**City of
Richmond**

Report to Development Permit Panel

File: DP 14-674133

Re: Application by Western Verona Garden Holdings Ltd. for a Development Permit
at 9211 and 9231 No. 2 Road

SITE PLAN
 SCALE 3/32" = 1'-0"

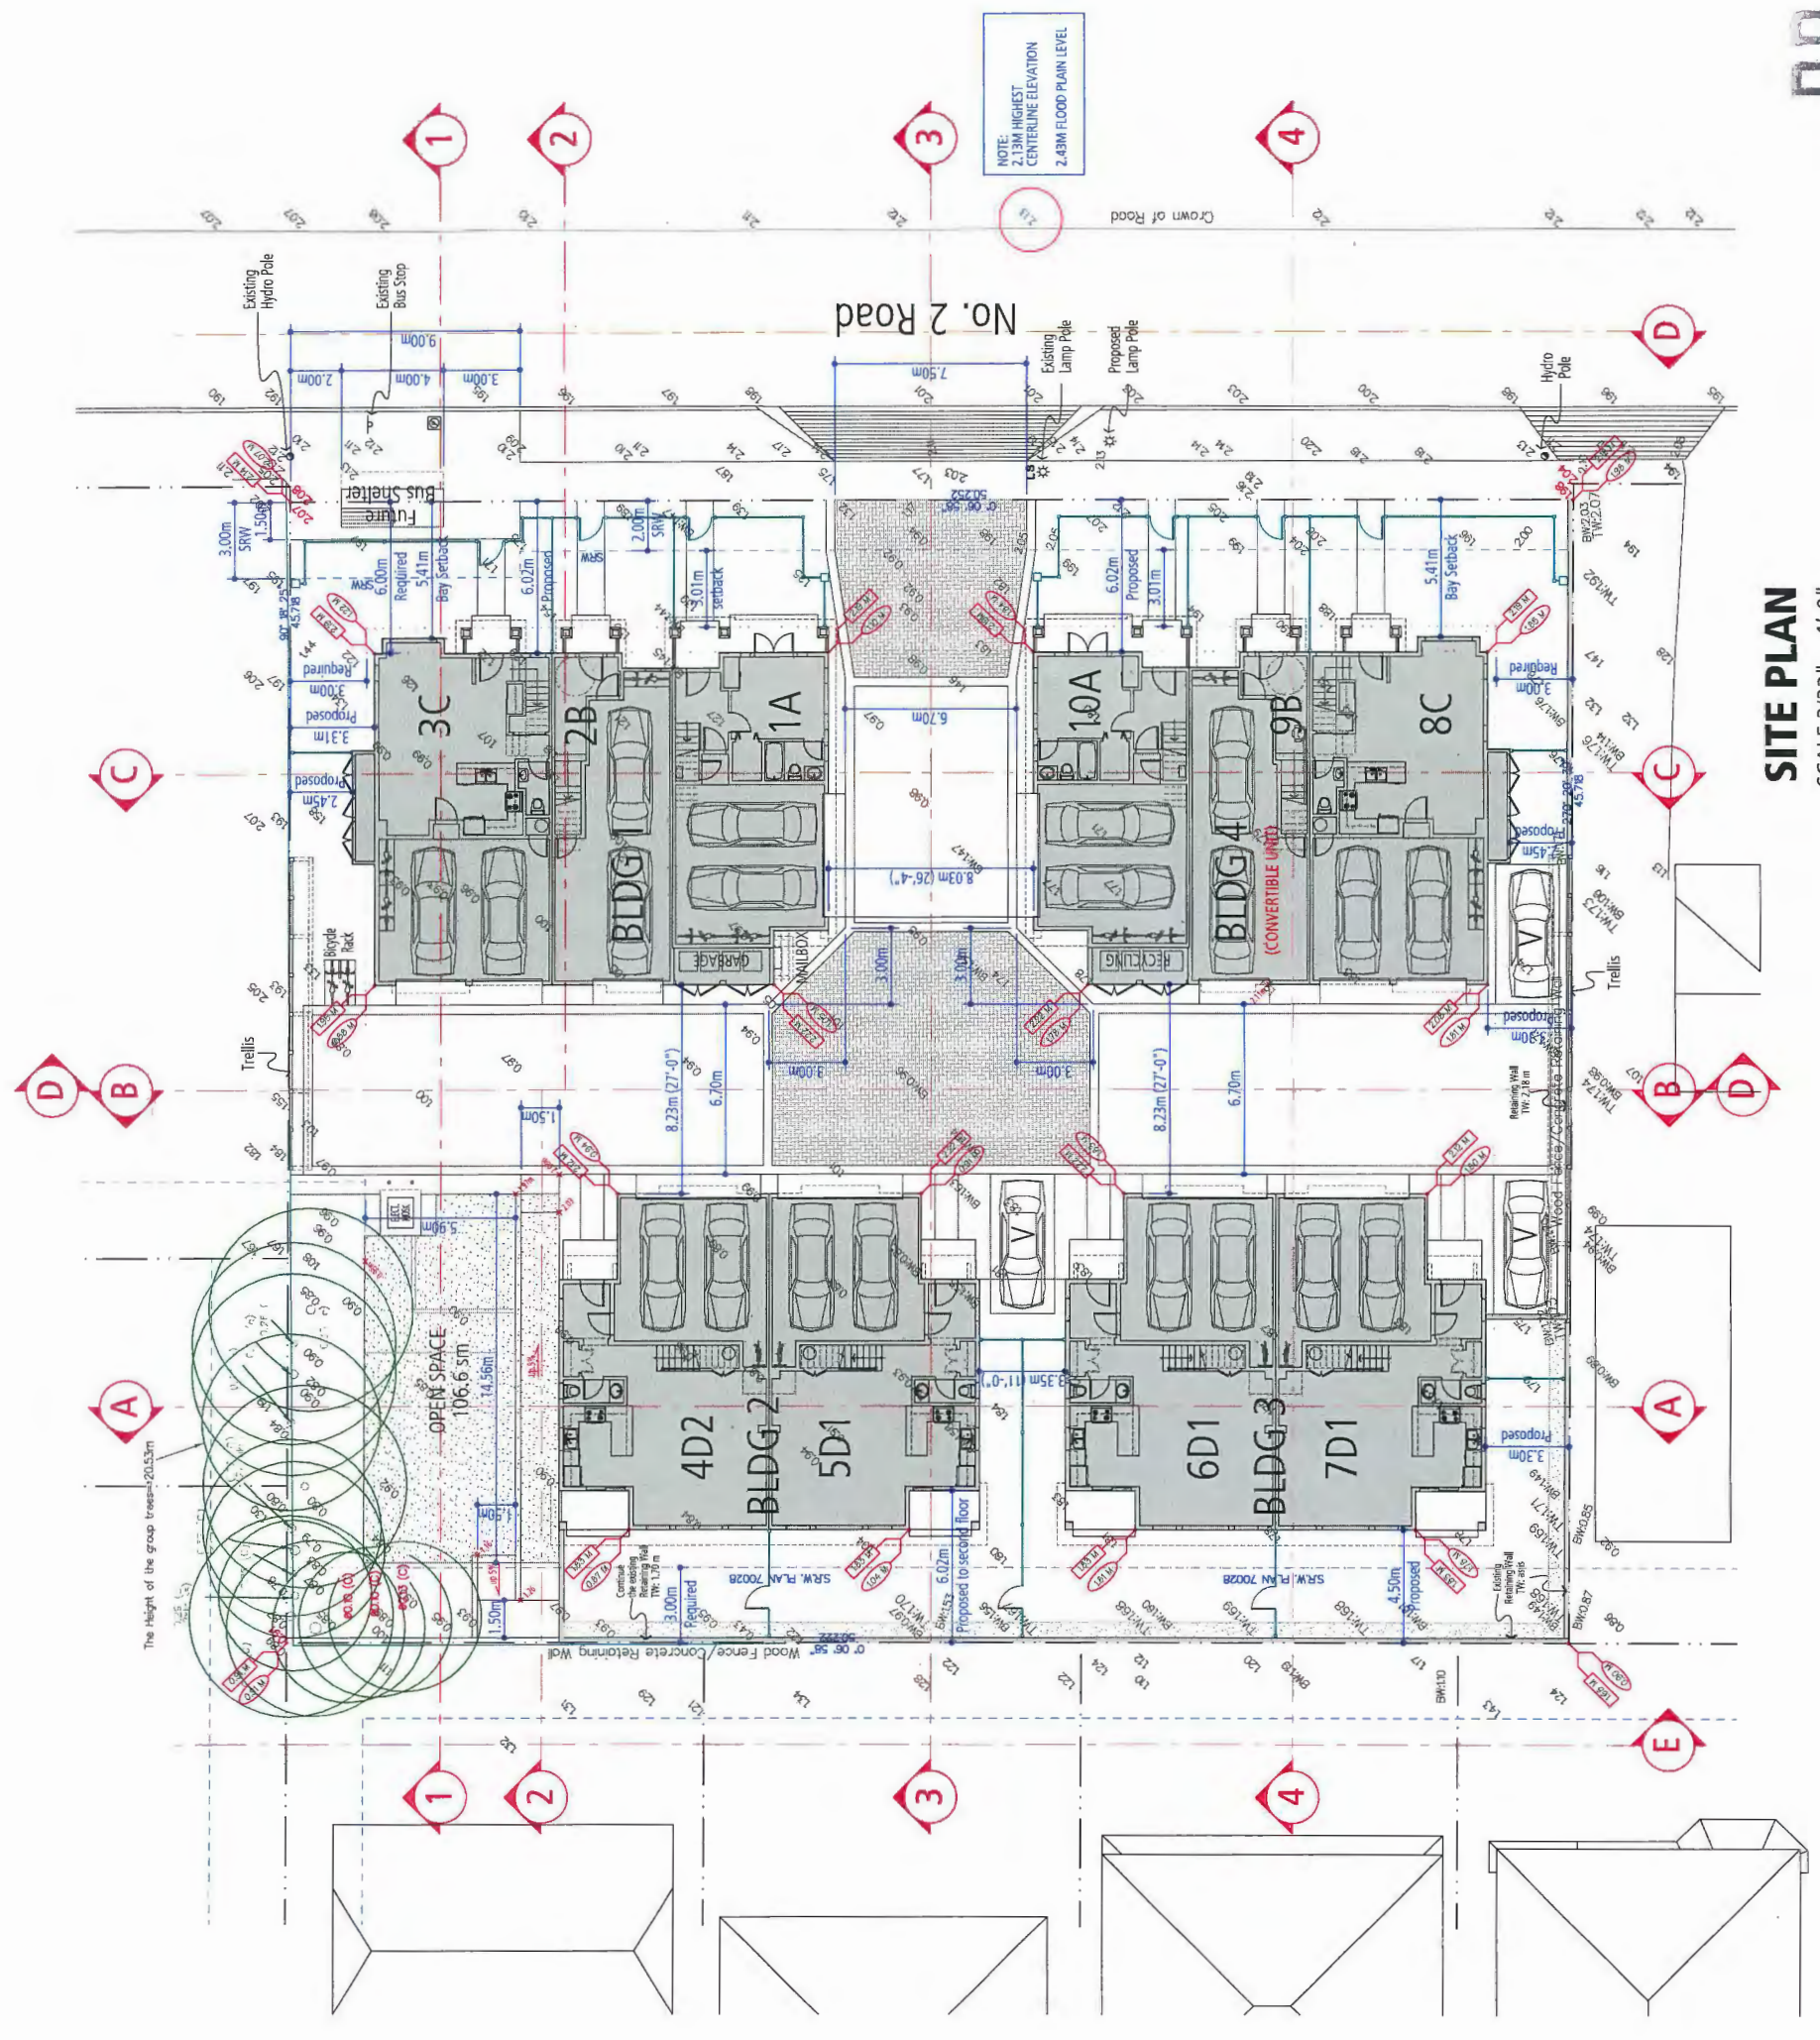
- the proposed location of double car garages in Units 1A and 10A at the entry drive aisle pose a safety issue; consider introducing traffic calming measures at the driveway entry to mitigate this safety concern;
We proposed a decorative paver at the site entry and at the "T" intersection to provide the sense of entering to different area to slow the drivers down.

BUILDING 2 & 3 ELEVATIONS
SCALE 1/8" = 1'-0"

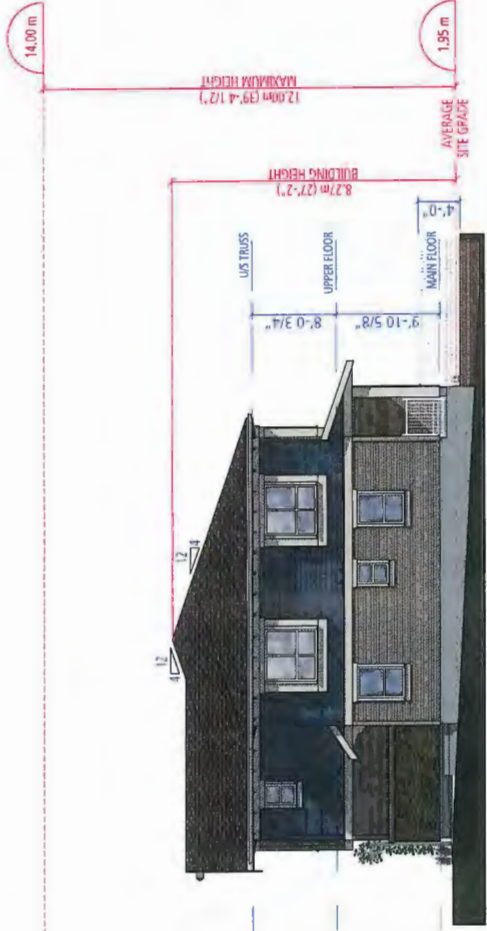
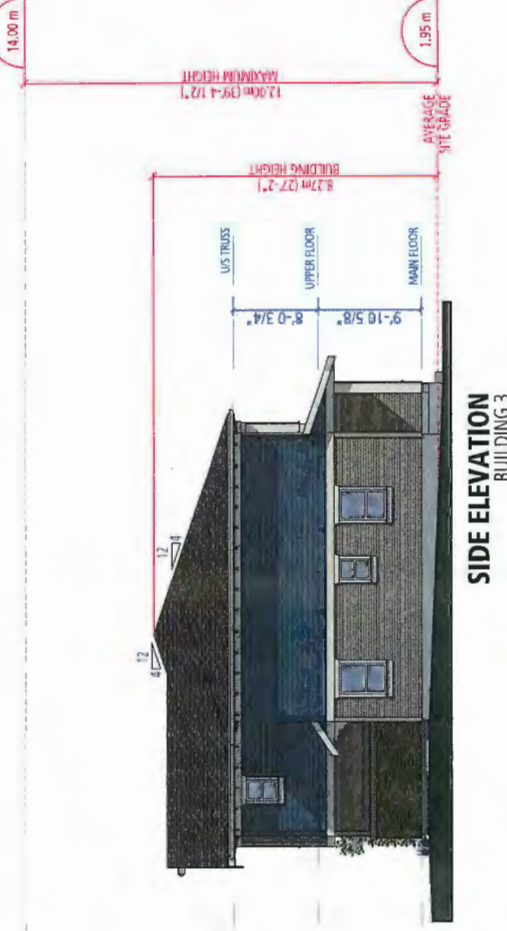
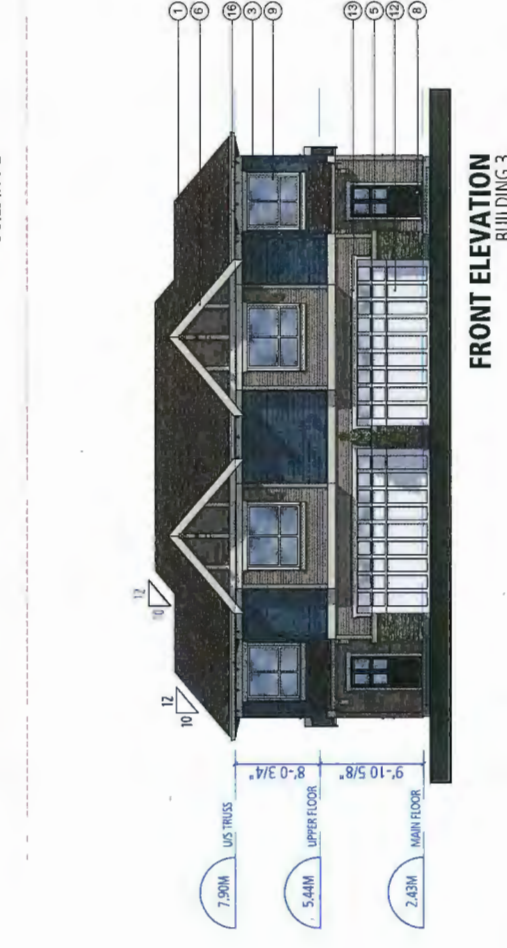
- back units respond to the neighbours' concern;
We revised the design and changed two windows in the middle to box-out windows to break up the row of the windows.

- appreciate the landscaping for the project, e.g. texture, paving and materiality;
No comment.
- the project is well-composed;
No comment.
- the two-storey rear buildings relate well vertically with the neighbouring single family homes; however, consider breaking up the volume by introducing elements and further architectural treatment, including breaking up the row of windows at the back of the rear buildings;
We revised the design and changed two windows in the middle to box-out windows to break up the row of the windows.
